Planning Approval Consistency Assessment Form

PROJECT
MILLER STREET CARPORT
 EXISTING CARPORT ALTERATIONS

PROJECT LOCATION
 243 MILLER STREET
 NORTH SYDNEY NSW 2060

Statement of Heritage Impact

Figure 4. Preliminary Design for Proposed alterations to carport Source: TfNSW Think Project Services P/L

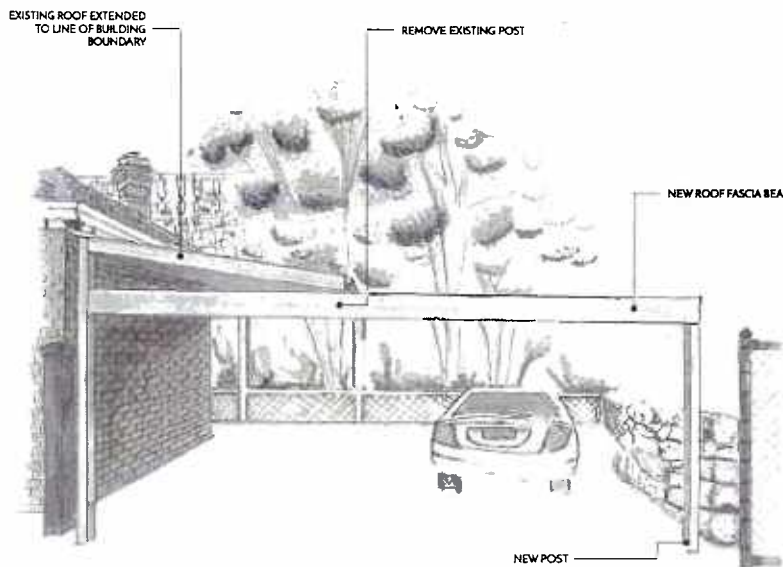
The proposed carport is designed to match the general appearance of the existing structure but with a wider street frontage (to allow space for access to the steps and platform lift). The roof is proposed to be Pale Eucalypt (again to match the existing) with a central section of tinted polycarbonate sheeting. The design is not only structurally optimistic it is also not in keeping with the quality of the listed building or its streetscape.

The proposed modification of the existing carport to provide clearances to access the route is less well considered and should be revised. Any new construction, especially one so visible in the streetscape and in such proximity to the listed house requires a more appropriate design, as noted in section 4.

The proposed design of the carport modifications is intrusive and not in keeping with the listed building. Consideration should be given to providing a more appropriate design following the recommendations of the Former NSW Heritage Office publication "Design in Context". For example the new carport could be a free standing timber framed structure complimenting (rather than copying) the quality of the older house by good design.

The carport design requires further development in consultation with a suitably experienced conservation architect.

Subject to refinement of the carport design, and submission for approval by a conservation architect, the impact would be minimal and therefore an acceptable heritage outcome.

Figure 4 Route of path. Source: TfNSW

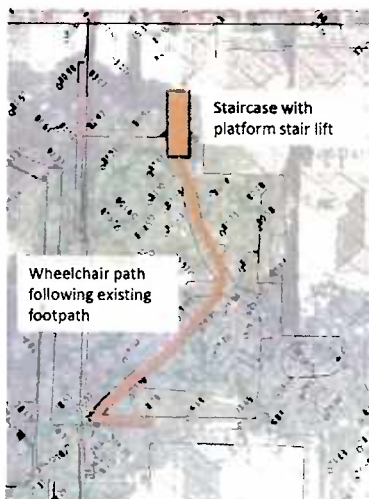
The insertion of necessary access to the rear building is generally appropriately planned and uses complementary materials and colours for the pathways, the chair lift and steps. Adverse impacts, for instance the impact on the garden landscape has been appropriately mitigated by using (where possible) existing pathways for the accessible route.

The proposed chair lift and steps are acceptable as the least intrusive means of achieving essential access to the lower garden levels.

The proposed pathway route and finishes limit change to the garden while providing an appropriate and compatible finish.
